OSSF Inspection Sheet

Permit of Authorization to Construct an On-Site Sewage Facility Permit Valid For One Year From Date Issued

Permit Number: 117851
Issued This Date: 09/17/2024
This permit is hereby given to: Heriberto Garza

OSSF DESIGN

RE – SEPTIC DESIGN
6301 US HWY 281
12.24 ACRE TRACT, SIMON FREECHILD SURVEY
SPRING BRANCH TX 78070
HERIBERTO GARZA

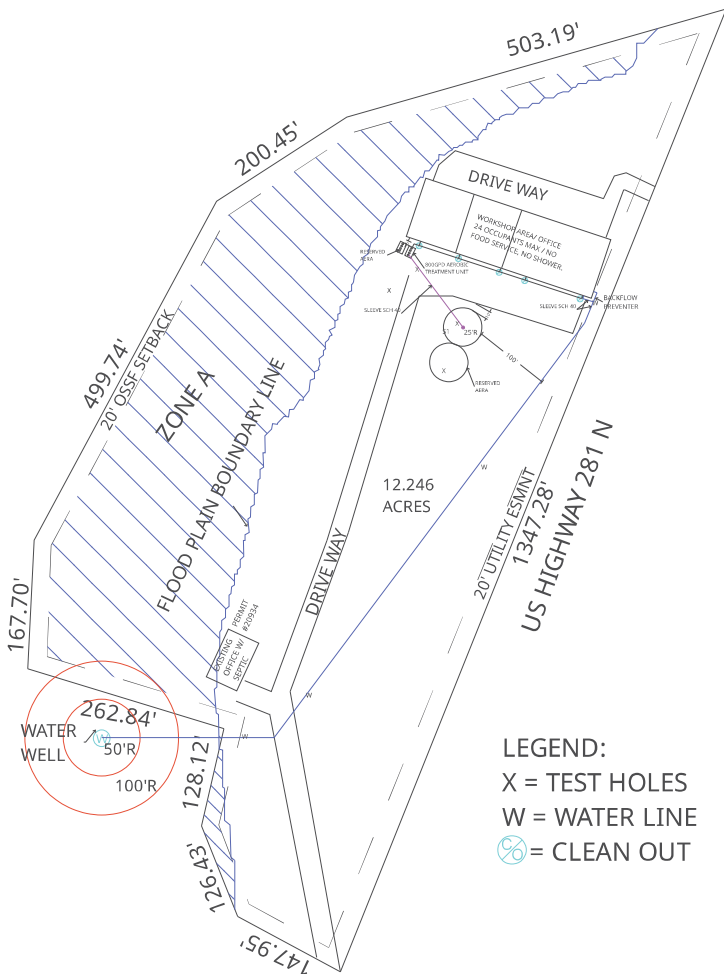
✓ The variance indicates equivalent protection when crossing but does not indicate what your requirements are for the water line within close proximity of the sewer line. Revise as needed and resubmit.

The referenced property has waterline that is approximately 1 to 2 feet away from the sewer line. This OSSF design will comply with requirements in Subchapter D: Rules and Regulations For Public Water Systems §290.38 – 290.47. All waterlines that is in close proximity or that crosses wastewater main or lateral shall be sleeved with SCH 40 or SDR 26 10' on each side where wastewater crosses or is in close proximity from the waterline.

At any residence or establishment where an actual or potential contamination hazard exists, additional protection shall be required at the meter in the form of an air gap or back flow prevention assembly. The type of backflow prevention assembly required shall be determined by the specific potential hazard identified in §290.47(f) of this title.

When a new waterline crosses under a wastewater main or lateral, the waterline shall be encased as described for wastewater mains or laterals (encased in a joint of at least 150 psi pressure class pipe) or constructed of ductile iron or steel pipe with mechanical or welded joints as appropriated. An absolute minimum separation distance of one foot between the waterline and the wastewater main or lateral shall be provided.

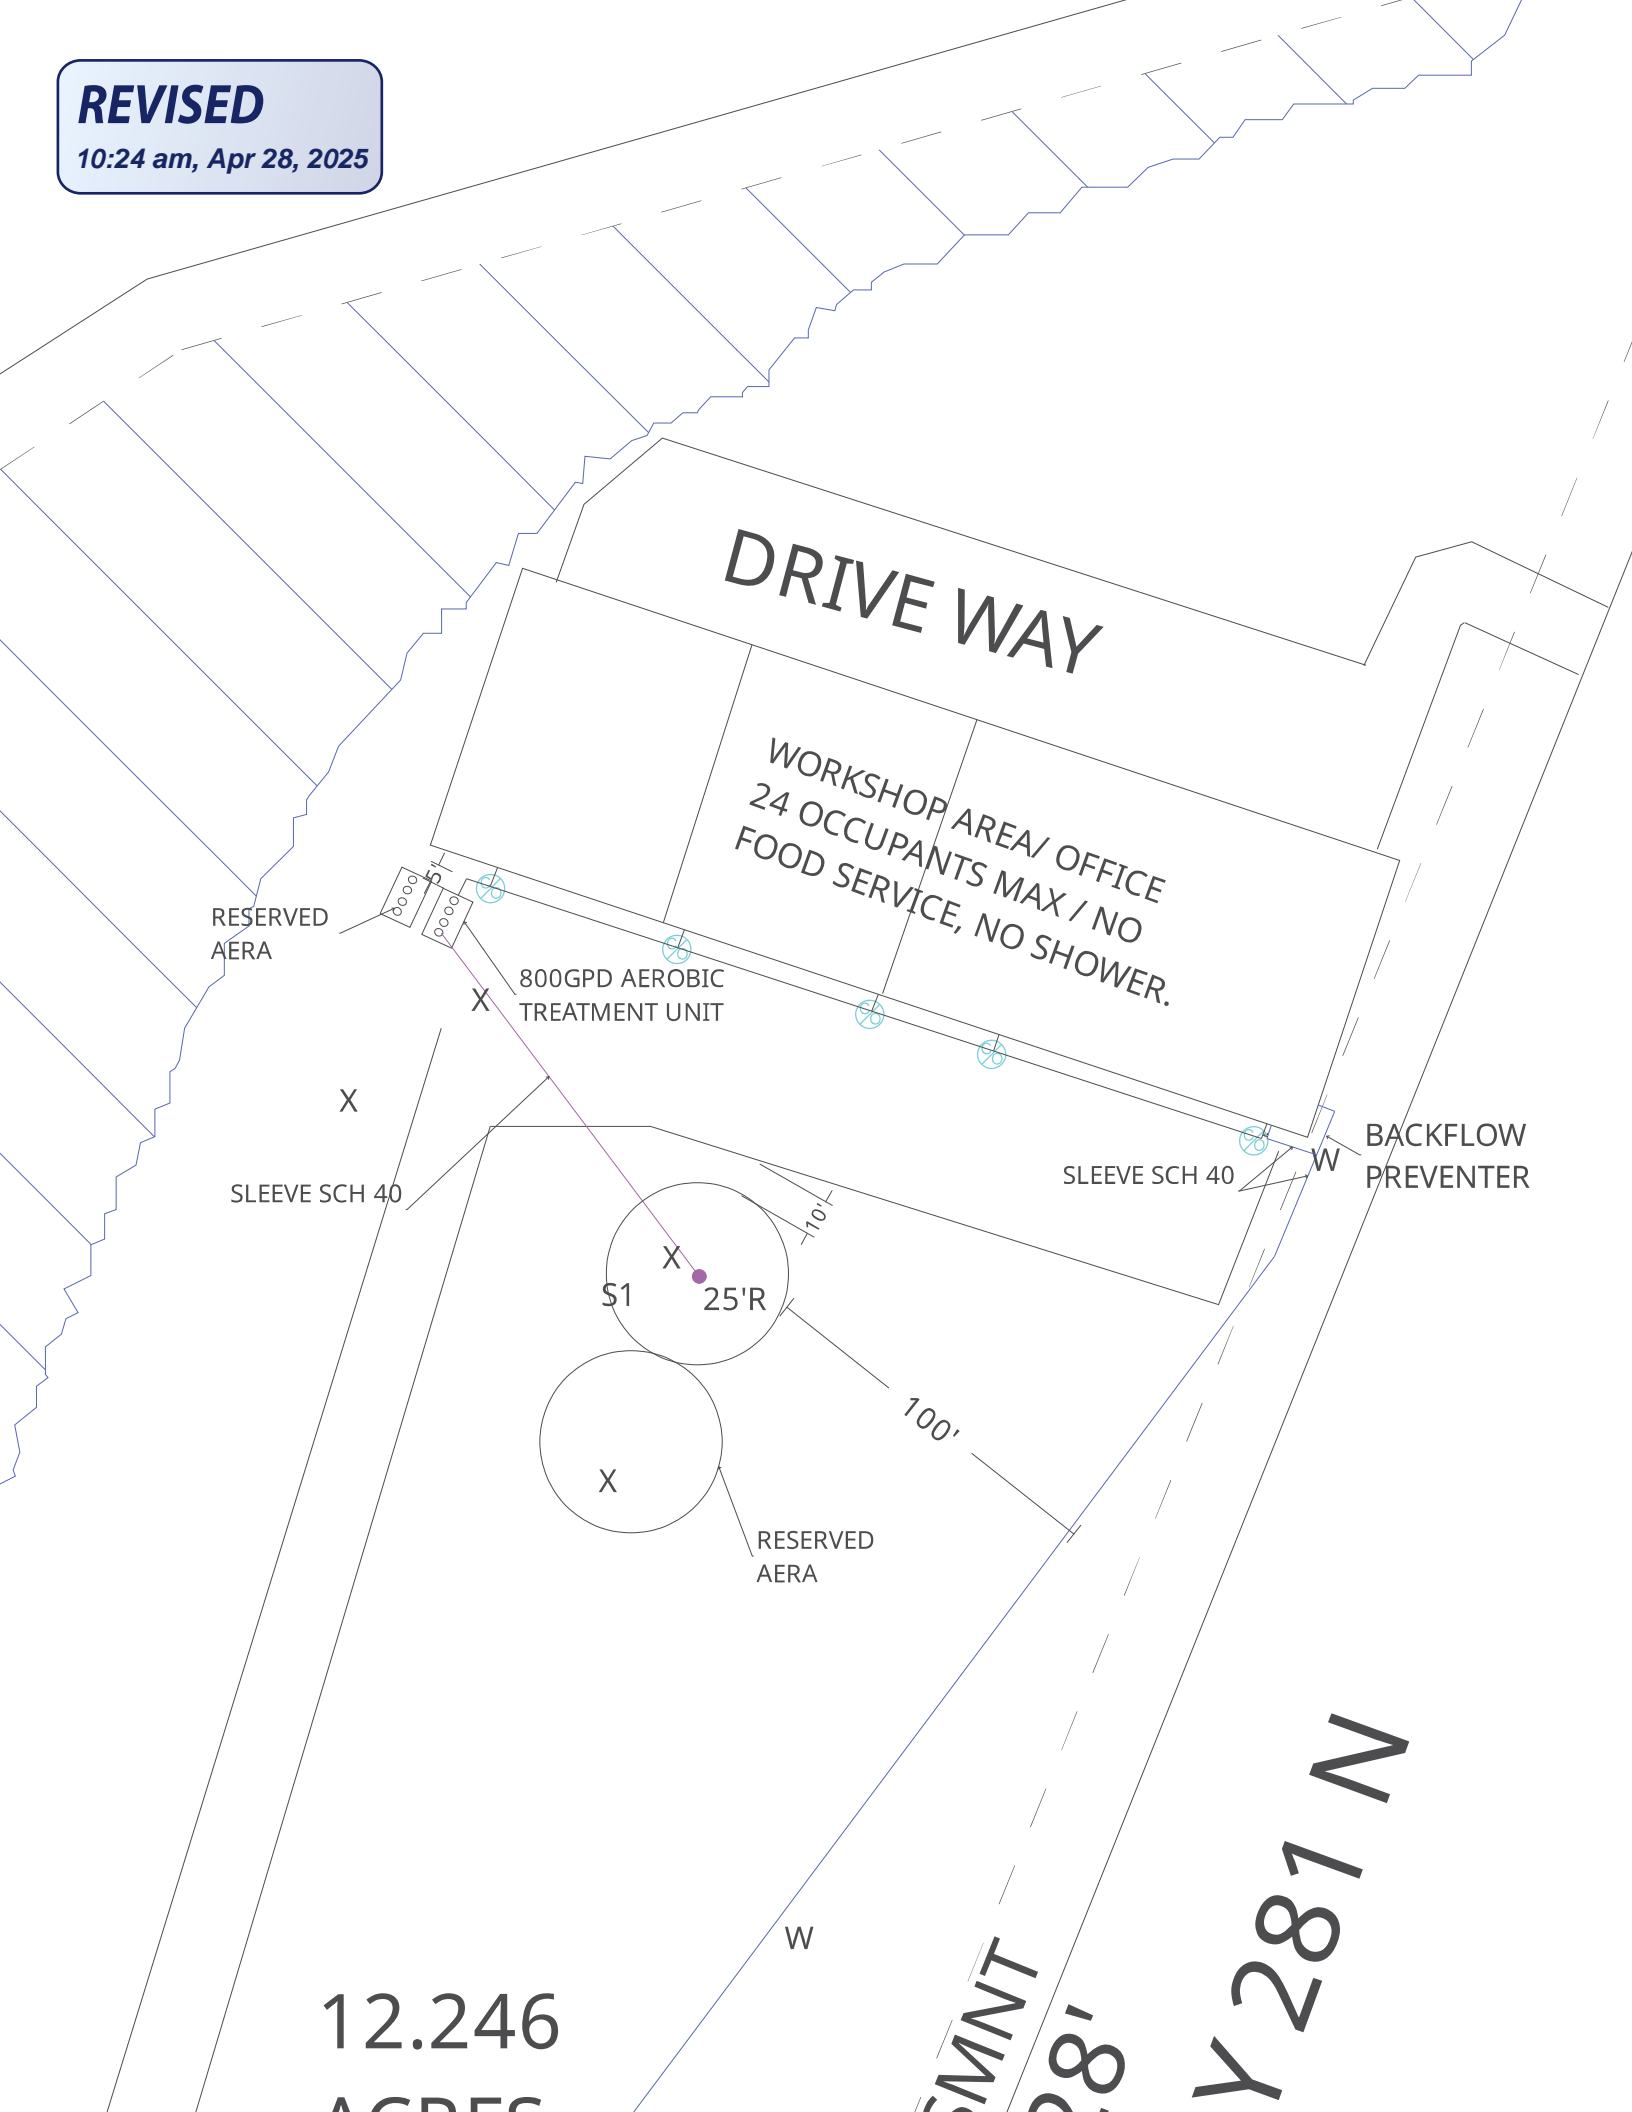
Also, please  show the driveway location on the design.

Re: Heriberto Garza
12.246 acres, 6301 US Hwy. 281
Application for Permit for Authorization to Construct an On-Site
Sewage Facility (OSSF)

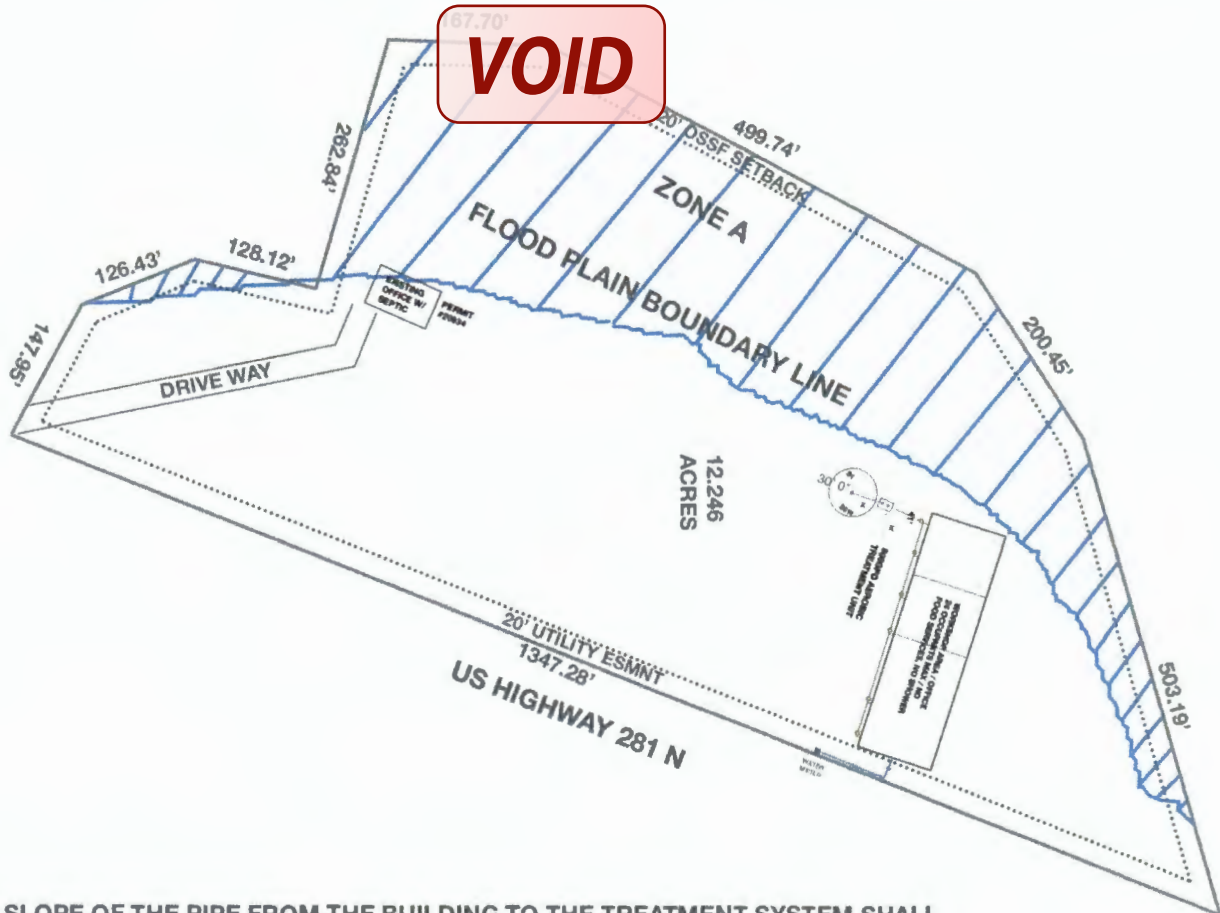
The following information is needed before I can continue processing the referenced permit submittal:

- 1. The address used is for the property next door.**
- 2. Show doubling area for both the treatment system and the disposal system.**
- 3. Revise as needed and resubmit.**
